**Banyule Planning Scheme Amendment C172bany
Heidelberg Structure Plan**

Panel Report

16 September 2024

Figure 4 Proposed Activity Centre Boundary

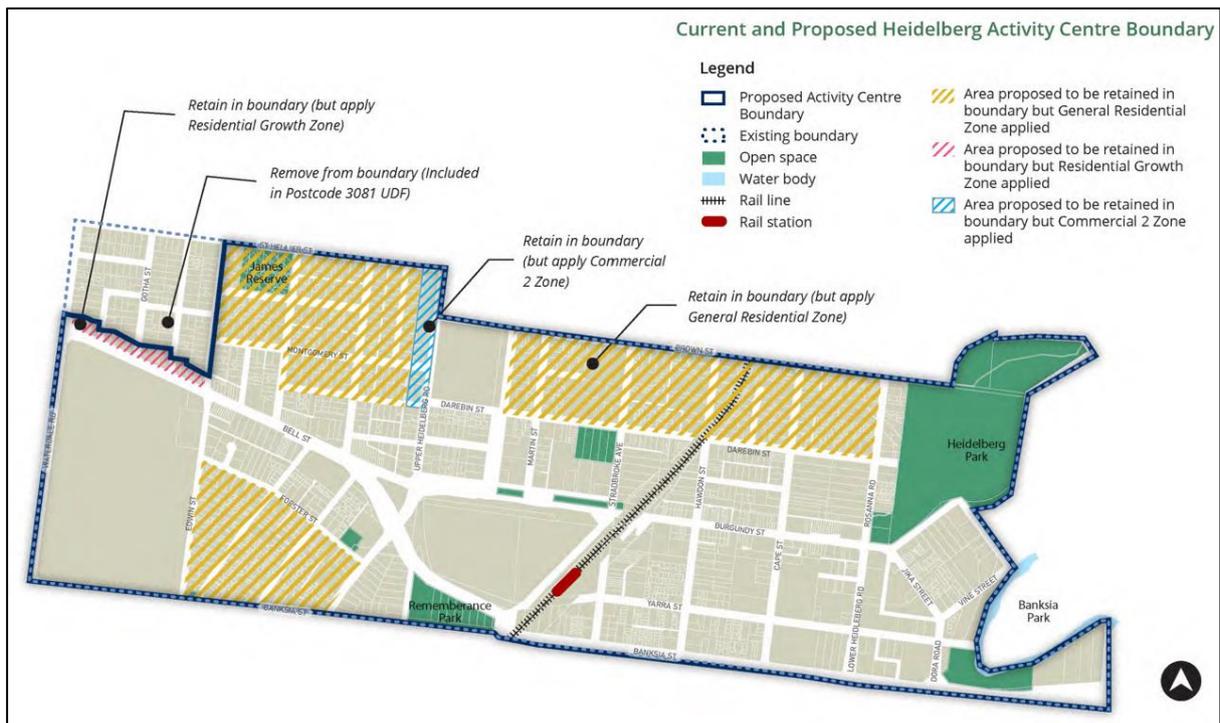
Submitter 87 questioned whether the Activity Centre boundary was consistent with the PPN58 criteria and considered the ACZ2 should apply to the entire Activity Centre area. The Amendment proposed to apply to the ACZ2 to the areas of commercial, mixed use and residential use in and around Bell and Burgundy Streets and to apply the GRZ and RGZ to the remaining residential areas within the Activity Centre.

The Panel has reservations about the approach to the application of the ACZ2 on some but not all land within the Activity Centre boundary, and whether this is an appropriate response to PPN58. For example, it questions if the ACZ2 should apply to all of the Activity Centre land, or if the Activity Centre boundary should move to include only the ACZ2 land.

Figure 5 Heidelberg Heights Hill Top area

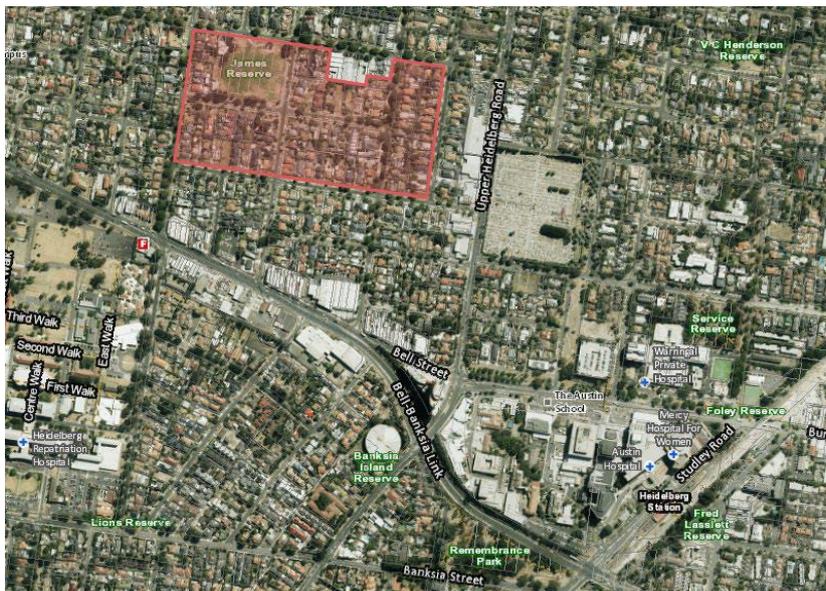
Submitter 4 (including a petition) sought the removal of an area known as the 'Heidelberg Heights Hill Top', from Frederick Street to Edwin Street (shown in red in Figure 5) from the Activity Centre. These submitters considered that the unique neighbourhood character and significant biodiversity of the area, and in particular James Reserve, made it inappropriate for inclusion in the Activity Centre.

The Panel does not support the exclusion of the 'Heidelberg Heights Hill Tops' area from the Activity Centre. This area is an existing part of the Activity Centre as outlined in the 2010 Structure Plan and at Clause 11.03-1L-02 of the Planning Scheme.

Figure 7 Warringal Private Hospital land

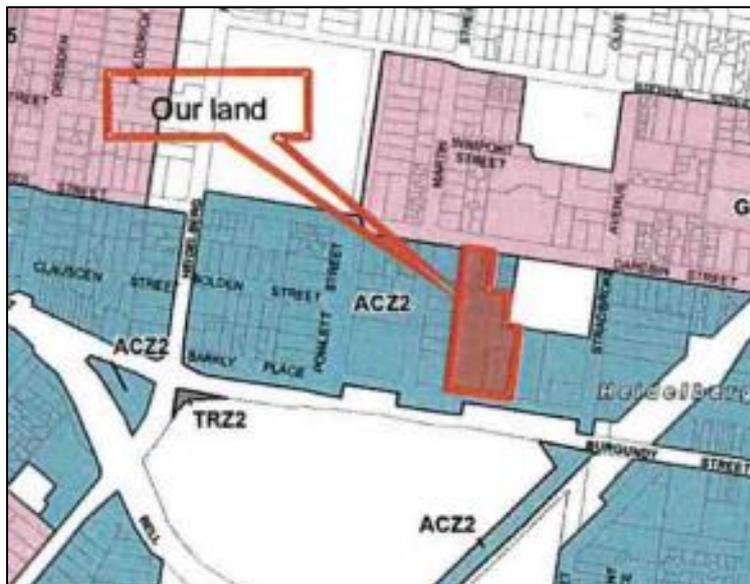
Ramsay Health Care, on behalf of the owner of Warringal Private Hospital, supported the strategic intent of the Amendment but submitted the whole of the hospital land at 81 and 83 Darebin Street and 214 and 216 Burgundy Street, Heidelberg (see Figure 7) should be in sub-precinct 4C (and not sub-precinct 4B). Sub-precinct 4B nominates a 'transitional' building height of 20 metres with sub-precinct 4C nominating 26 metres (see Figure 8). It submitted:

- the proposed height limit serves no purpose in the context of an existing planning permit that approves two towers up to a maximum height of 38 metres
- sub-precinct 4B should be revised to sub-precinct 4C (as it applies to the land generally bounded by Burgundy Street, Martin Street, Stradbroke Avenue and Darebin Street) with the maximum building height amended to reflect the existing approval of 38 metres.

Figure 8 Precinct 4 map

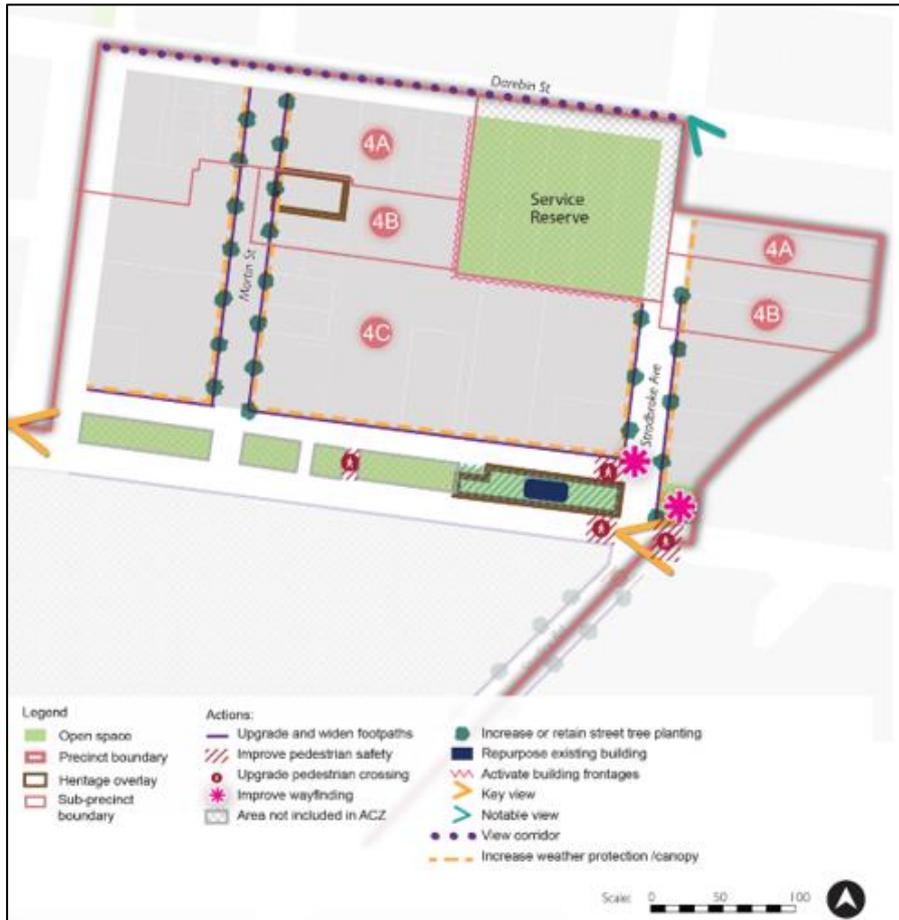
Submitter 23 took issue with the discretionary height limit proposed for 16 Powlett Street which sits within sub-precinct 4A (see Figure 9). It submitted the discretionary 13.5-metre height limit is too low given it has already been exceeded by existing built form at 91 Darebin Street, Heidelberg (also within sub-precinct 4A). Council agreed the designation of 16 Powlett Street should be revised to sub-precinct 4B which would provide a 20-metre preferred height limit.

- Redesignate 16 Powlett Street from sub-precinct 4A to sub-precinct 4B.
 - g) Amend the Precinct map in Clause 5.5-1 to clarify the precinct boundaries in Thames Street between Precincts 5 and 6.
